What are the differences between DSLC-2 MSLC-2 and DSLC-2XT MSLC-2XT ?

Clemens - 2024-01-16 - MSLC-2

possibly beyond. This document provides an overview of what to expect from the successor products, namely MSLC-2XT/DSLC-2XT respectively.

DSLC-2-XT Wiring Diagram PCB1

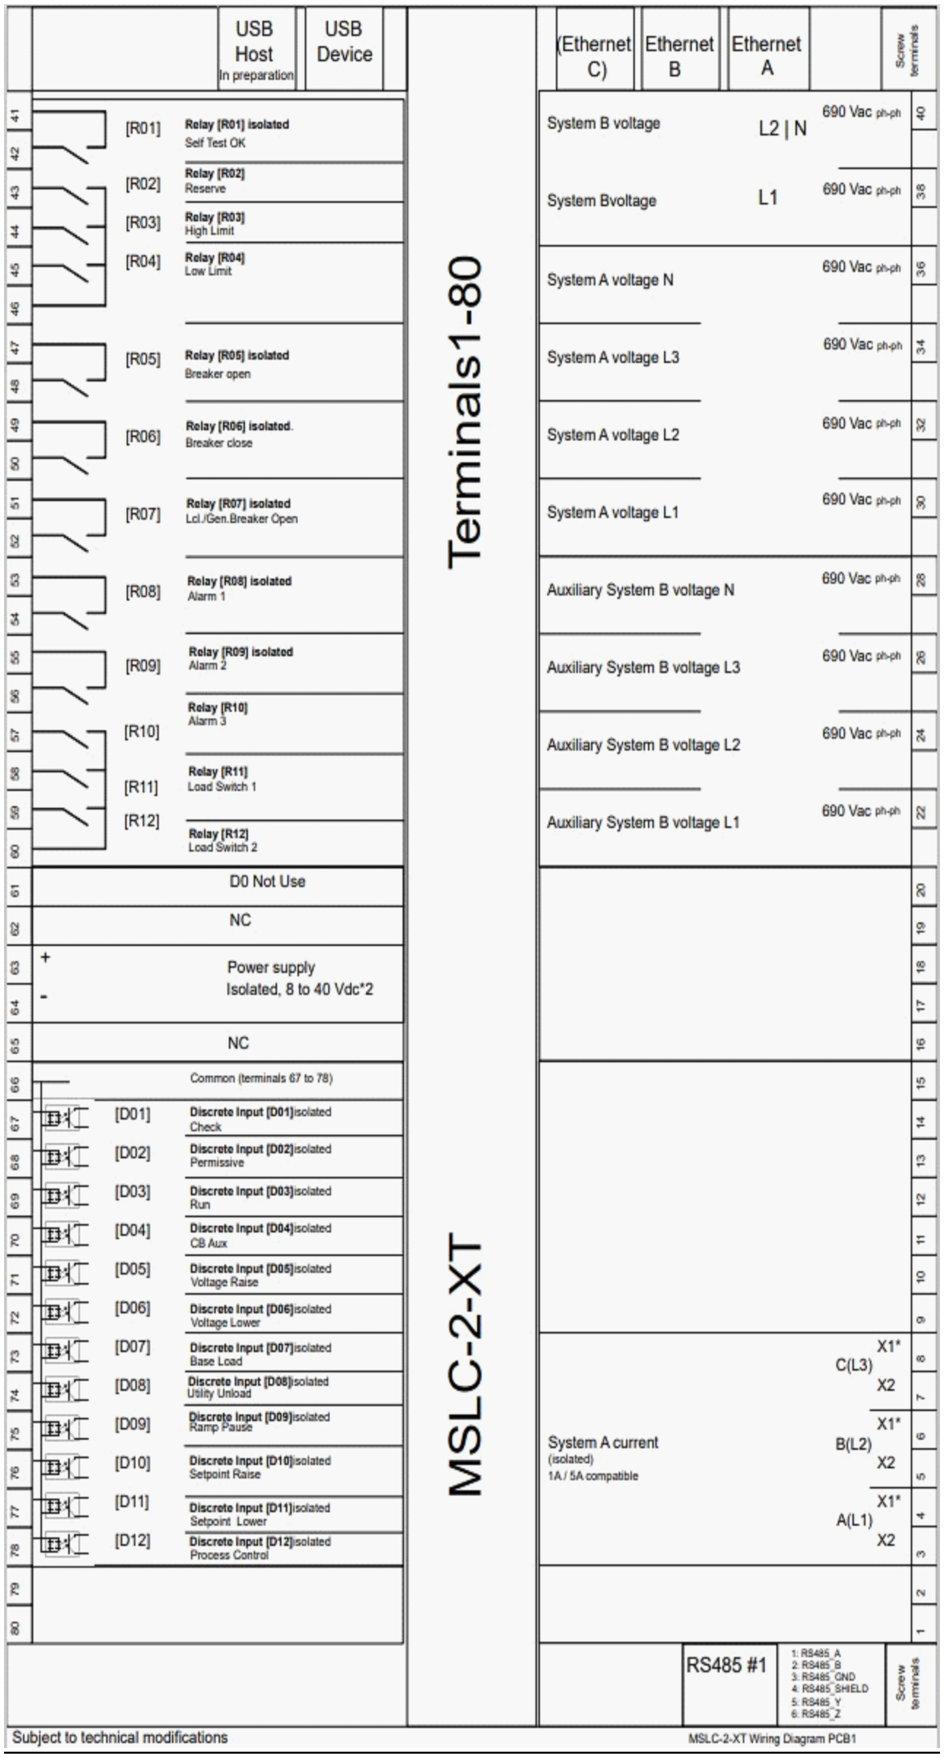
terminal deltas DSLC-2 / DSLC-2XT

Wiring diagram (DSLC-2XT)
